PRODUCT SERVICE NOTICE

REPLACEMENT OF CHARACTER SLUGS IN DATA PRINTER CORP.
CHAINTRAIN PRINTER CT-6644

FIELD CHANGE ORDER

Equipment Affected 2263, 2263V, 5570, 5571 Data Corp Chaintrain Printer

FIGURE 1 210-7386 PCA, RESISTOR/CAPACITOR LOCATIONS, COMPONENT SIDE

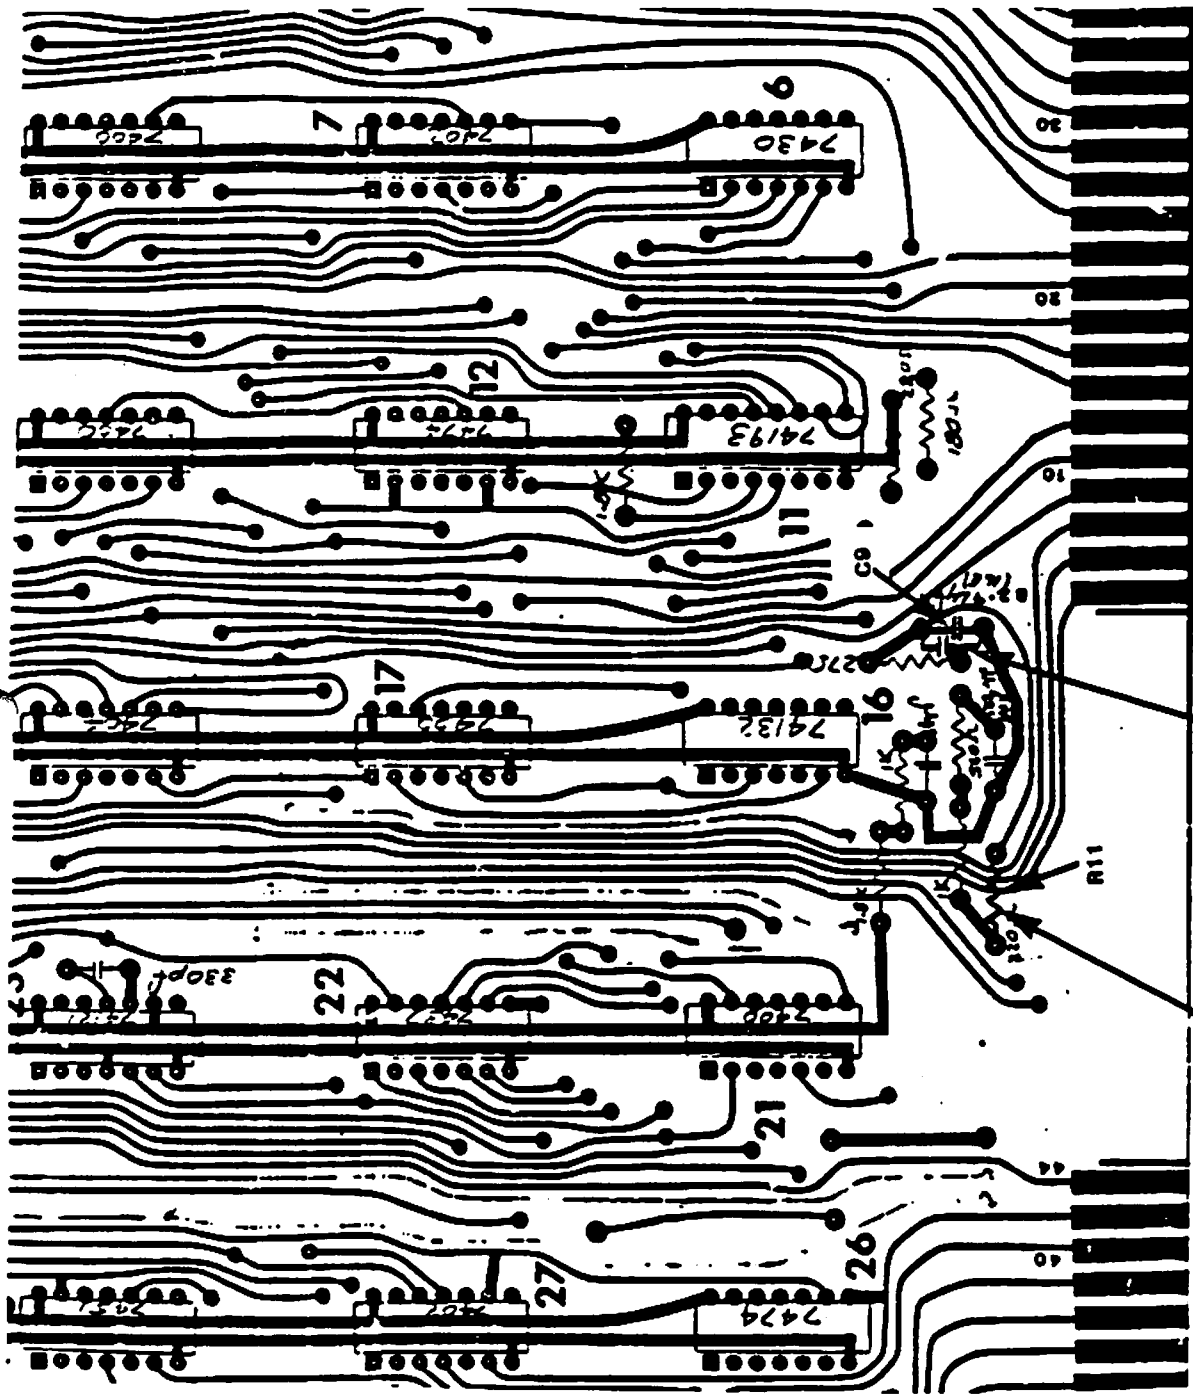
To fix a paper-out switch problem which results in an intermittent "paper-out" indication and the printer printing over previous text upon re-selecting.

A capacitor is added and a resistor is changed on the 210-7386 Paper Feed Control PCA.

- E. Change R11 from a 220 ohm 1/4W 5% resistor (330-2023) to a 6.8K ohm 1/4W 5% (330-3069).

- F. Add a .1uf capacitor (300-1918) in parallel with C9. Do this by hook soldering the leads of the .1uf capacitor to the leads of C9.
- G. Check for solder splashes, cold joints and shorts.
- H. Remove the E-Rev 1 sticker from the 210-7386 PCA. Place an E-Rev 2 sticker on the upper right corner of the circuit side of the 210-7386 PCA.
- I. Reassemble the unit by reversing Steps A - D above.
- J. Document installation of the FCO by completing a Call Report or Activity Report.

ADD A .1UF
CAPACITOR
(300-1018)

CHANGER11 TO
6.6K OHM 1/4W 5%
RESISTOR
(330-3059)

Ribbons 725-0162

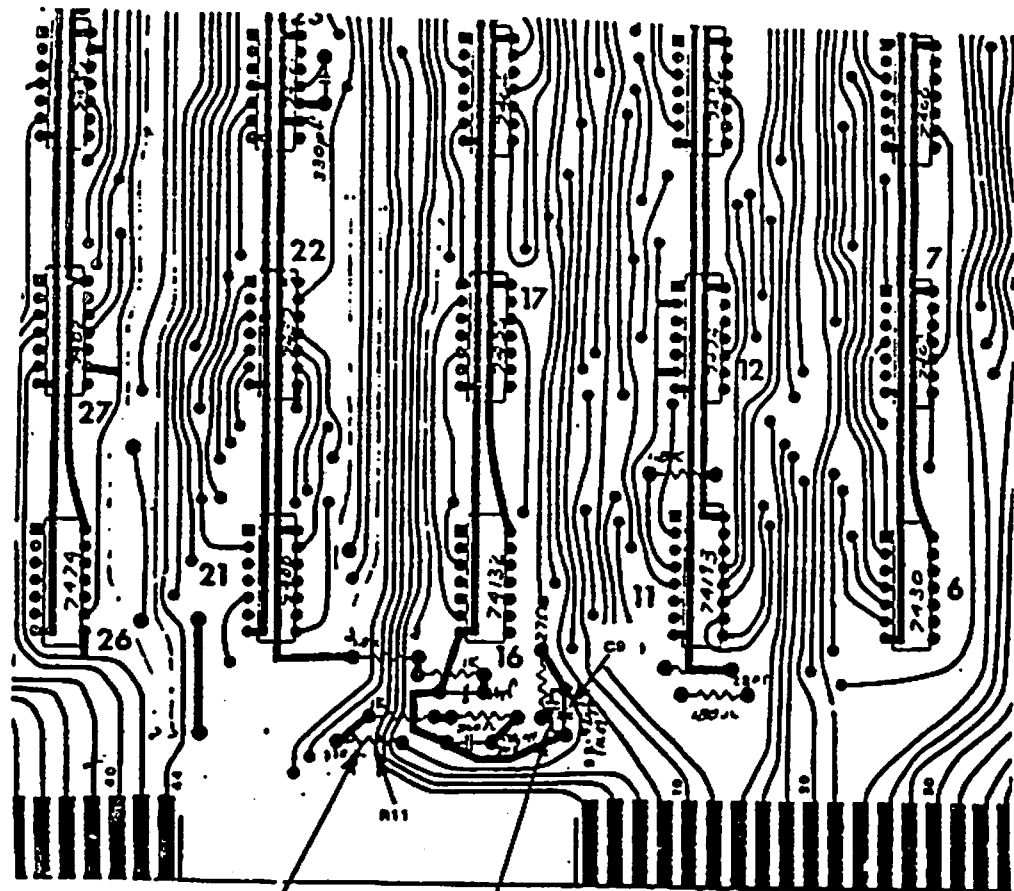
At present there exists two types of fabric mesh on the 725-0162 ribbon.

- A. A dark ink colored mesh which works correctly and should not introduce any ribbon reversing problems.
- B. A lighter colored mesh (off-white) which inhibits the passing of light, thereby causing intermittent ribbon reversing problems.

Ribbon "B" can be exchanged at no cost to customers through Returned Goods Supplies Division, telephone number 1-800-225-0234.
